APPLICATION NO.	FILING DATE	FIRST NAMED INVENTOR	ATTORNEY DOCKET NO.	CONFIRMATION NO.
10/608,671	06/27/2003	Michael J. Pugia	017191.0033 (MSA-3452)	5201
28524 7590 10/15/2007 SIEMENS CORPORATION INTELLECTUAL PROPERTY DEPARTMENT 170 WOOD AVENUE SOUTH ISELIN, NJ 08830			EXAMINER SINES, BRIAN J	
			ART UNIT 1797	PAPER NUMBER
			MAIL DATE 10/15/2007	DELIVERY MODE PAPER

Office Action Summary	Application No.	Applicant(s)	
	10/608,671	PUGIA ET AL.	
	Examiner	Art Unit	
	Brian J. Sines	1797

DETAILED ACTION***Response to Arguments***

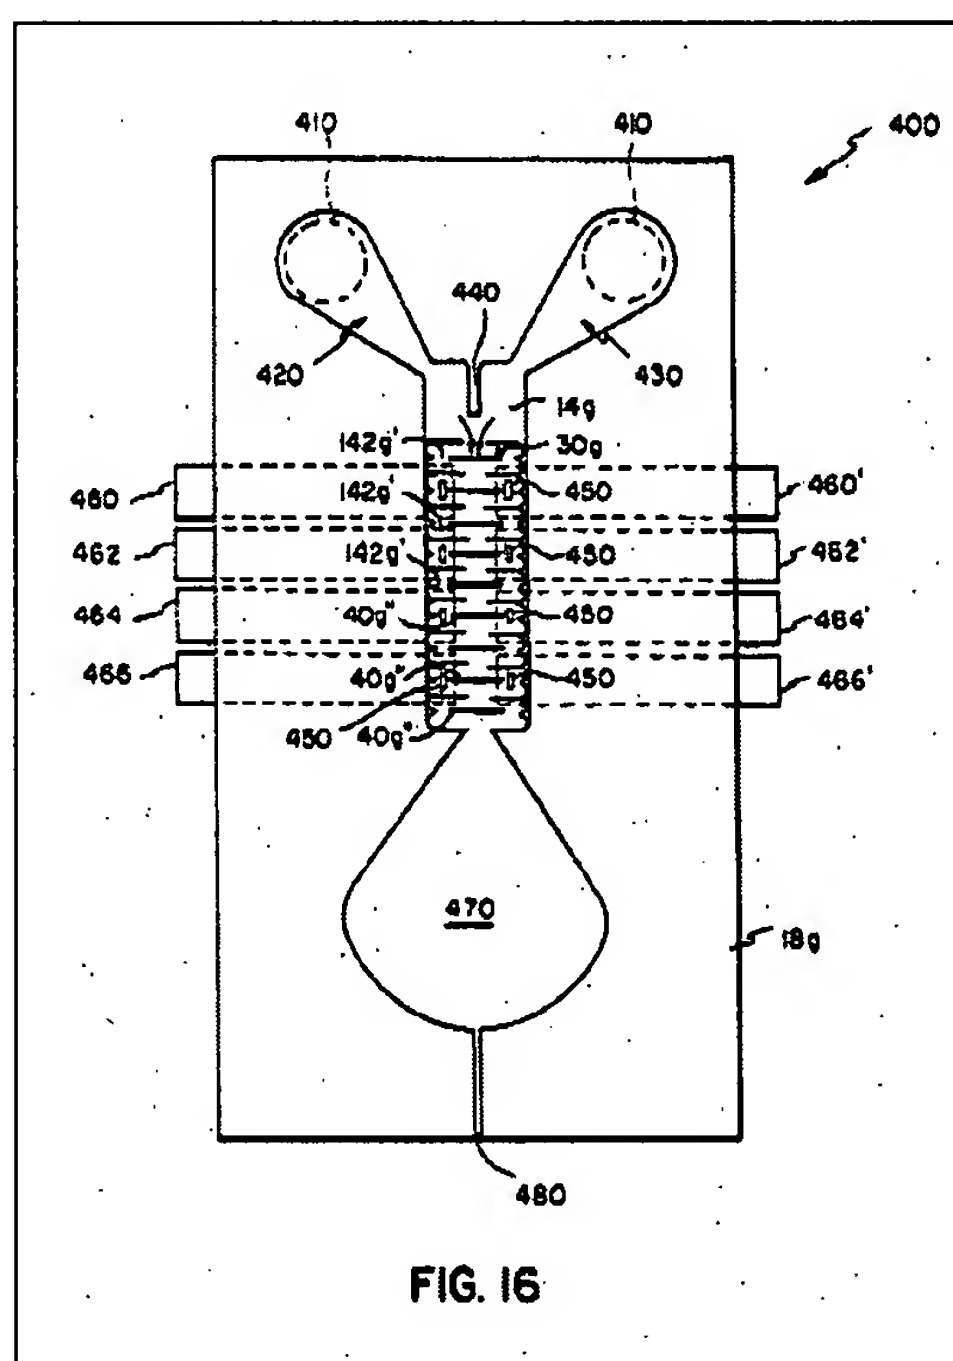
Columbus '476 teaches the incorporation of an overflow chamber 470 within a microfluidic device to facilitate effective sample fluid introduction and subsequent processing (see figure 16). Therefore, it would have been obvious to a person of ordinary skill in the art to incorporate an overflow chamber within the disclosed microfluidic device to facilitate effective sample fluid introduction and subsequent processing.

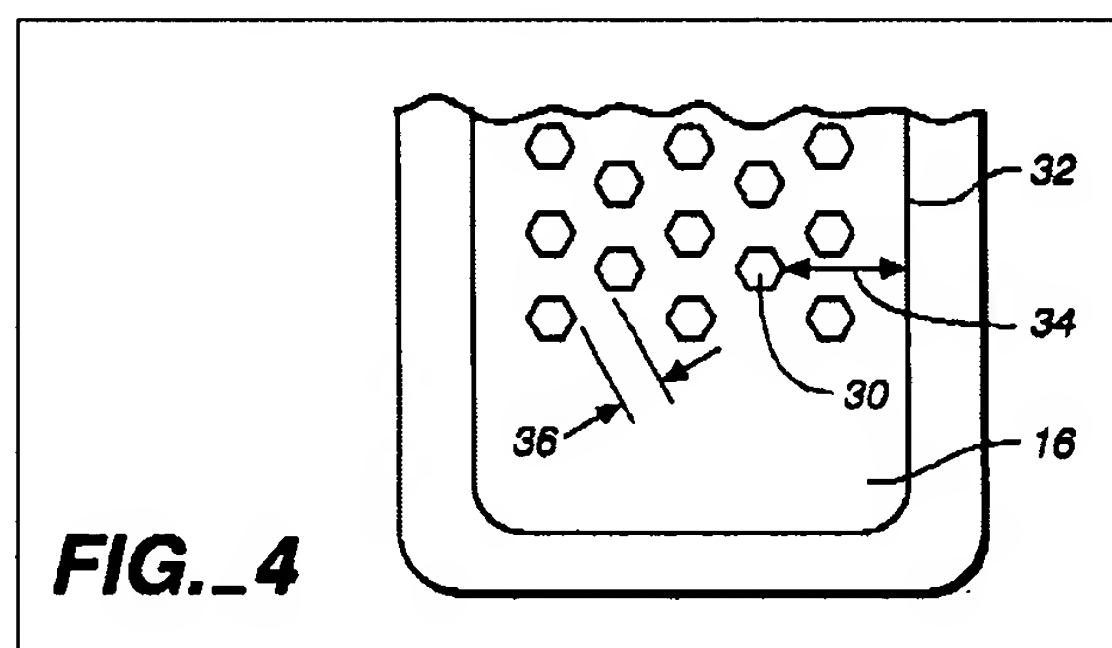
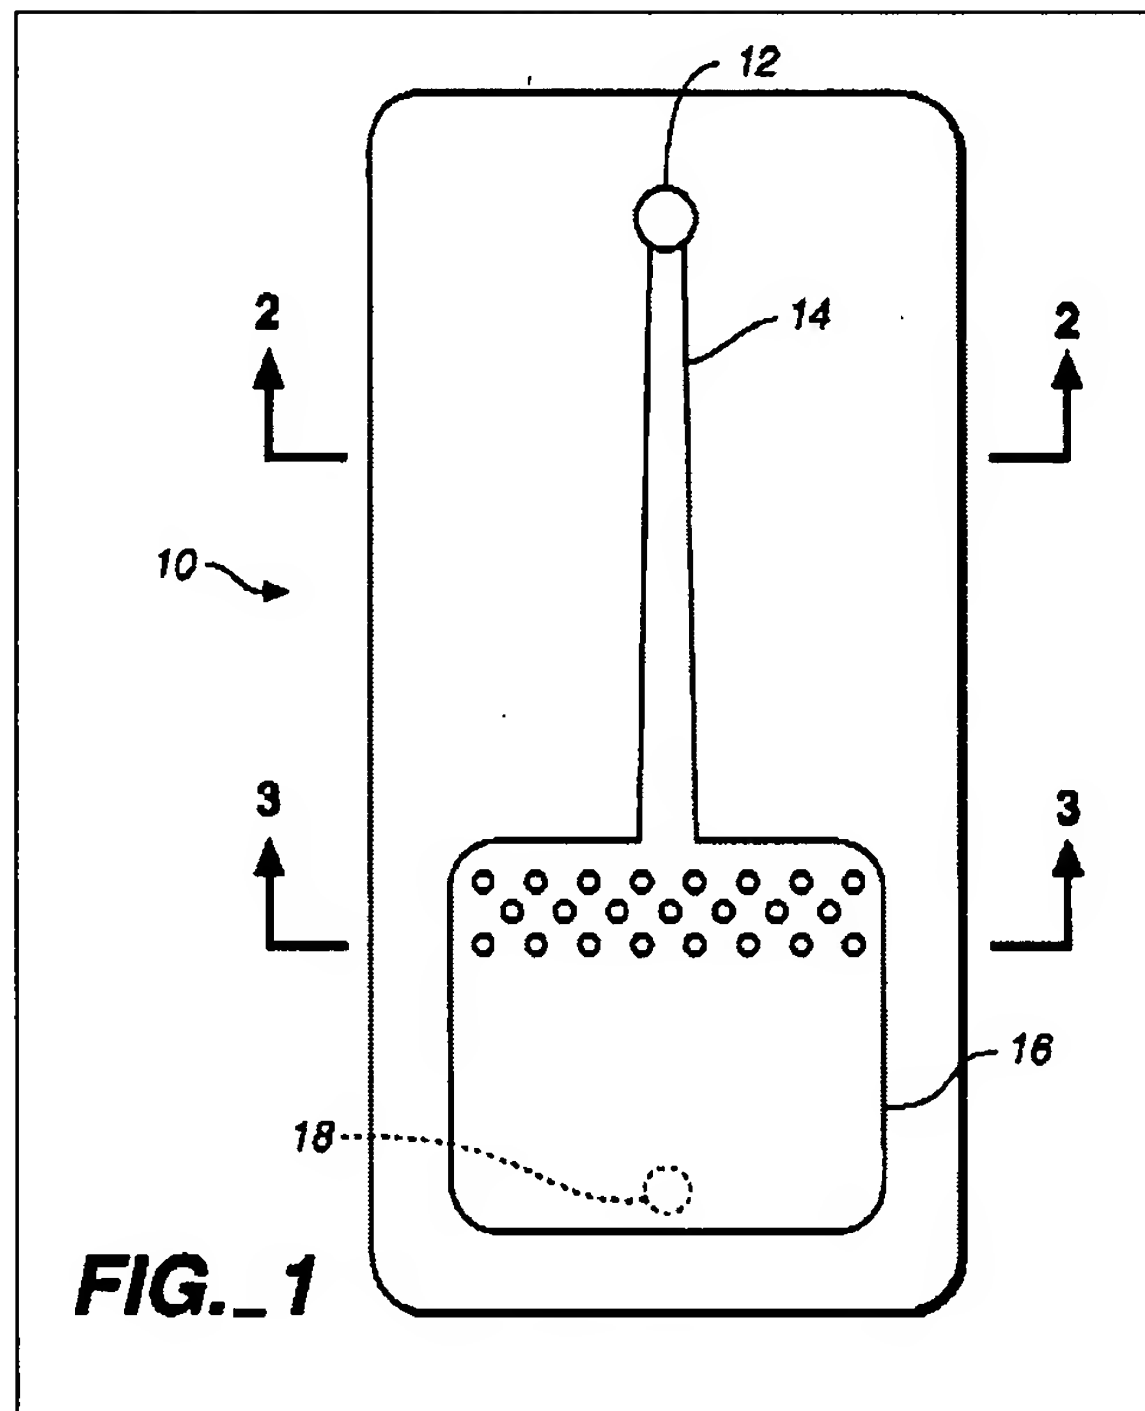
Regarding claim 1, Buechler teaches a microfluidic device comprising: an inlet port 12; an enclosed capillary passageway 14 in fluid communication with the inlet port 12; an enclosed inlet chamber (e.g., distal region 16) comprising an array of post structures (i.e., capillarity-

inducing structures 30); and a vent structure (i.e., escape port 18) (see col. 5, line 21 – col. 7, line 43; figures 1 & 4). As shown in figure 1, the enclosed inlet chamber 16 is in fluid communication at one side or end side thereof with the enclosed capillary passageway 14. In addition, as shown in figure 1, the vent passageway 18 is positioned at a top side of the enclosed inlet chamber opposite the entry of the capillary passageway 14 into the enclosed inlet chamber 16.

With respect to the newly added recitation that the array of posts are disposed to provide a lower capillary force in the chamber relative to the capillary force in the capillary passageway, since the claim does not provide any specific structure or size dimensions for the device, it is unclear as to how this feature defines over the prior art device structure.

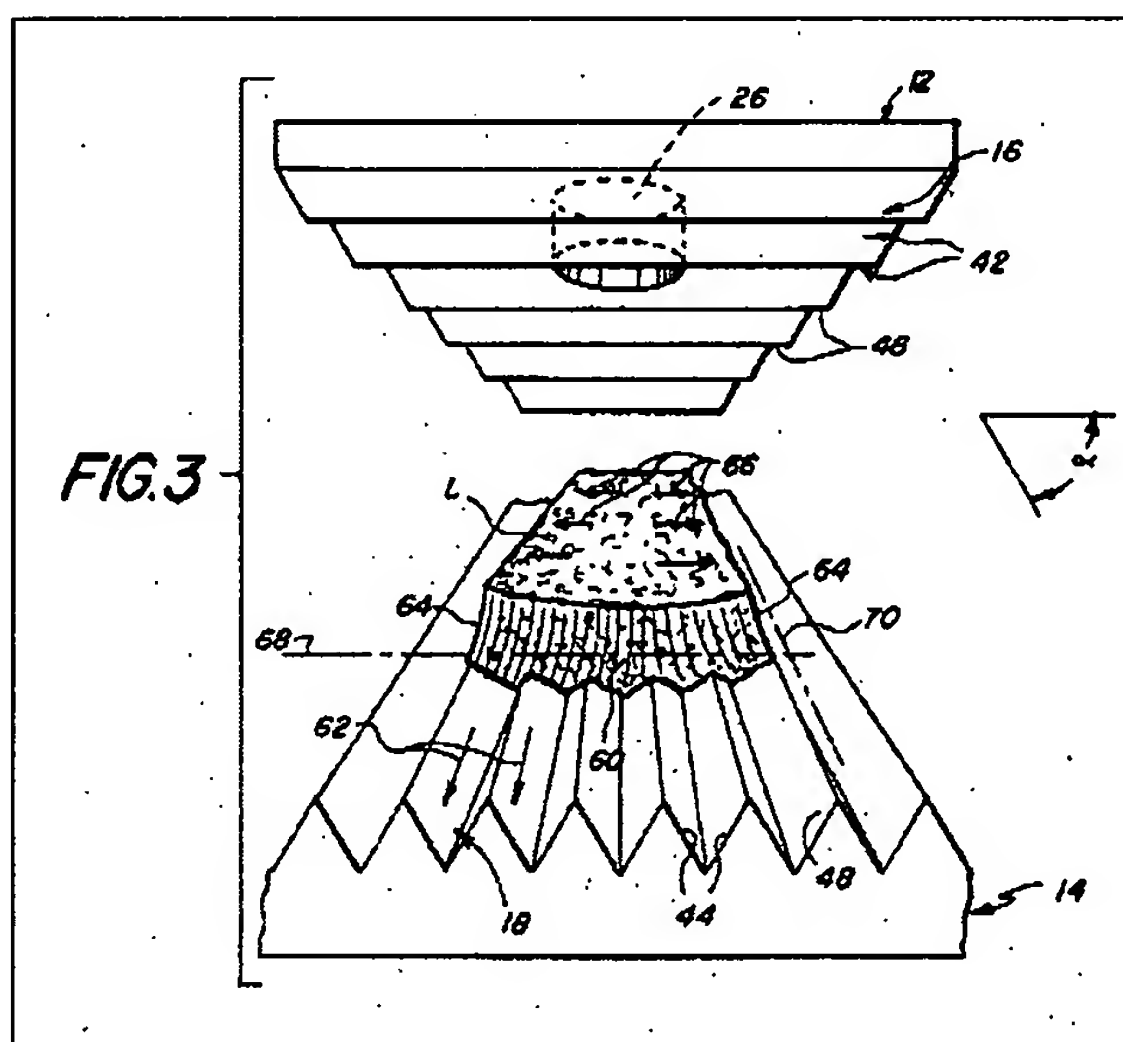
In this regard, Columbus teaches the use of groove structures (e.g., 42 & 44) for facilitating uniform fluid flow within microfluidic devices (see, e.g., col. 5, lines 1 – 55; figure 3). Columbus shows an entry aperture 26 leading to chamber structure underneath defined by surfaces 16 and 18, wherein grooves 42 and 44 extend across the top surfaces of this chamber (see figure 3).

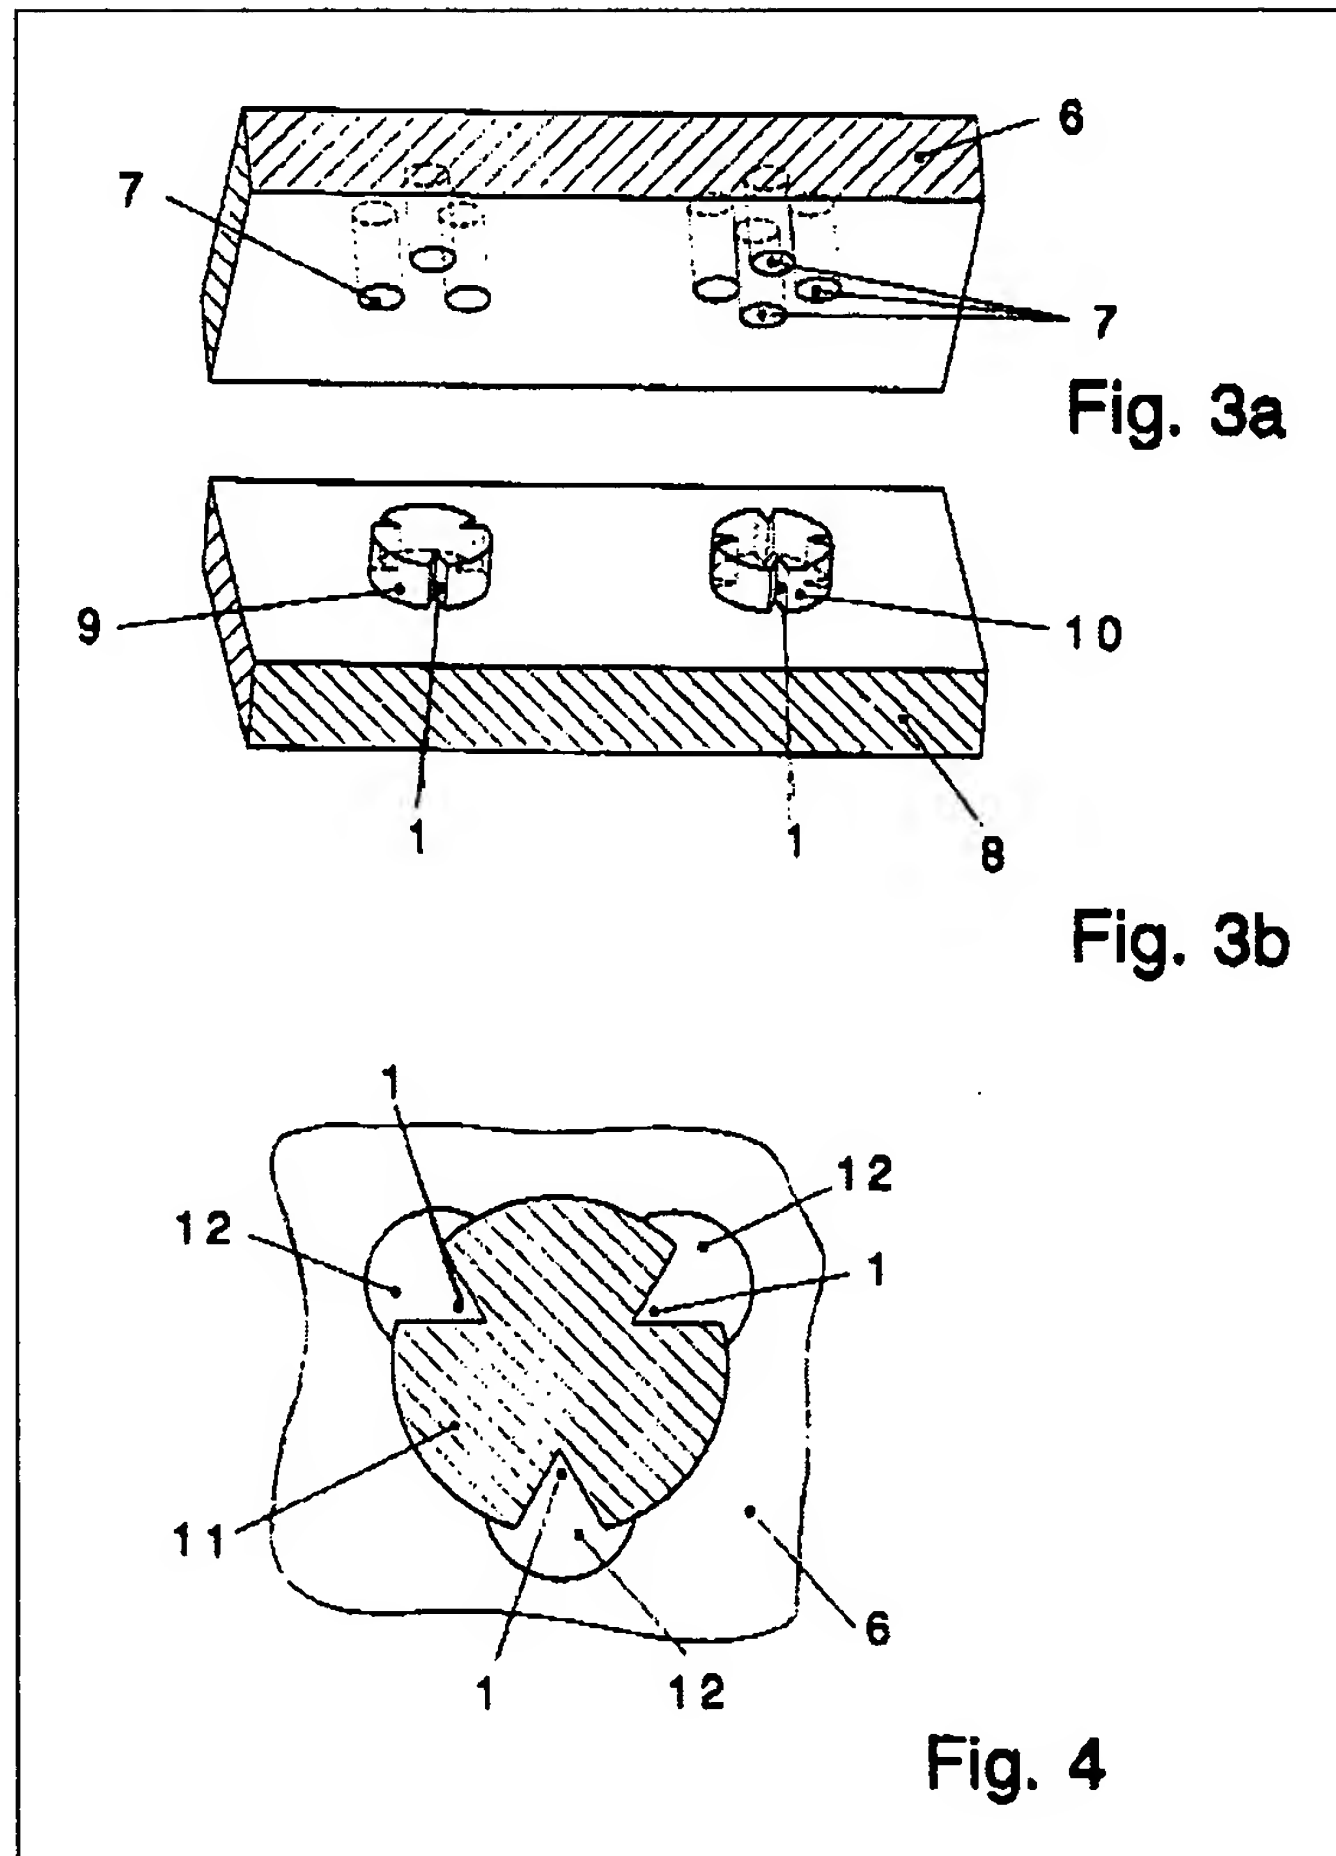
Regarding claims 4 and 6, Buechler and Columbus are silent to the specific teaching of incorporating wedge-shaped cut-out structures with either a groove or weir structure configuration as claimed within the disclosed microfluidic device. As shown in figure 3b, Peters does teach the incorporation of wedge-shaped cut-out structures (post or columnar projection 9 having wedge-shaped cut-outs 1) within a microfluidic apparatus for facilitating effective fluid control within a microfluidic device (see col. 1, line 10 – col. 6, line 67; figures 1a, 3b & 4).

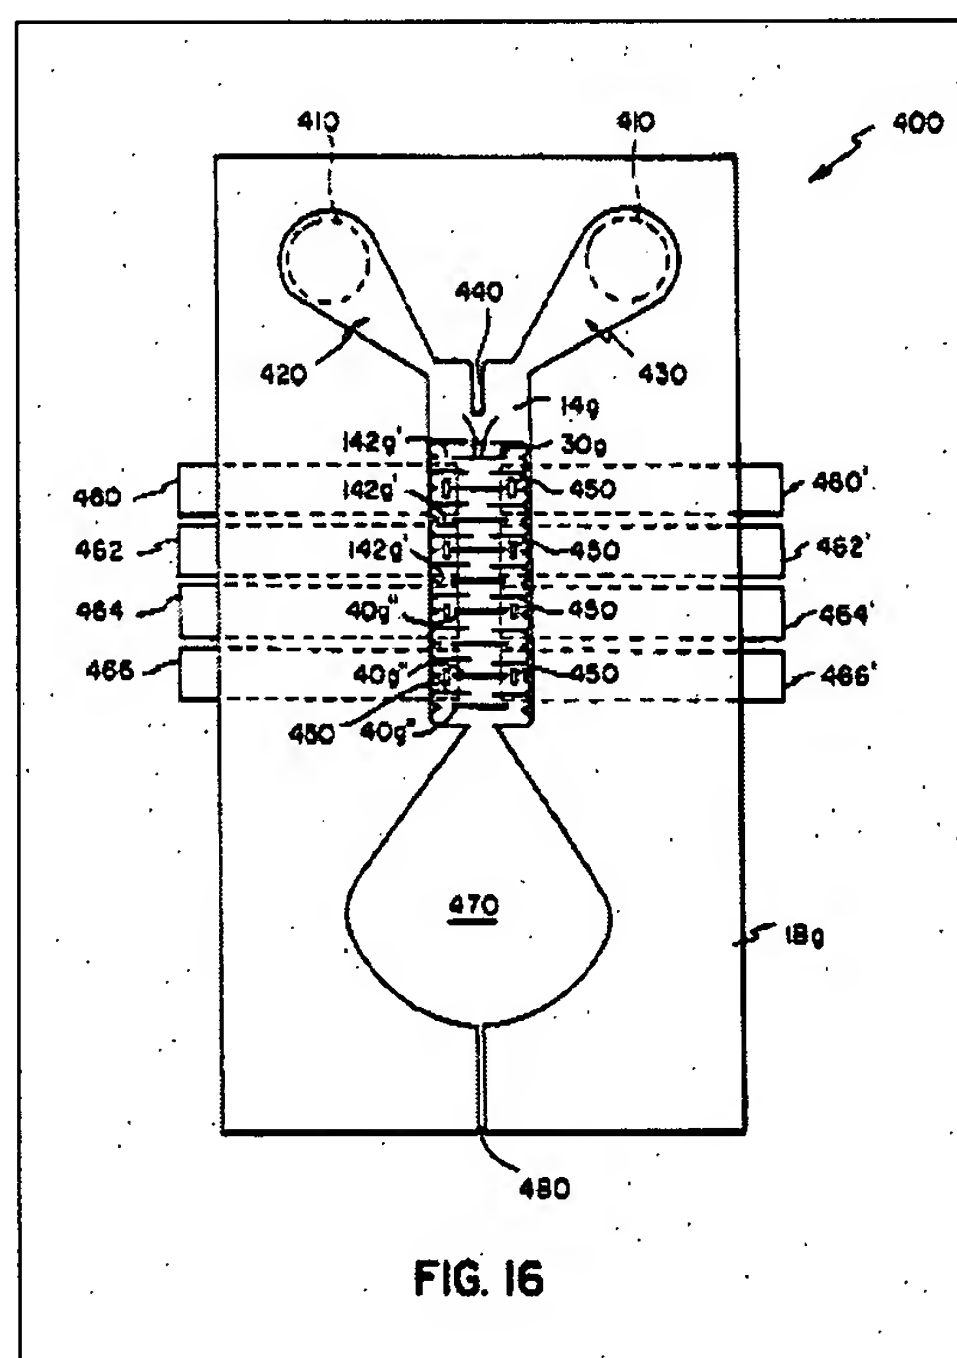
Columbus '476 teaches the incorporation of an overflow chamber 470 within a microfluidic device to facilitate effective sample fluid introduction and subsequent processing (see figure 16). Therefore, it would have been obvious to a person of ordinary skill in the art to incorporate an overflow chamber within the disclosed microfluidic device to facilitate effective sample fluid introduction and subsequent processing.
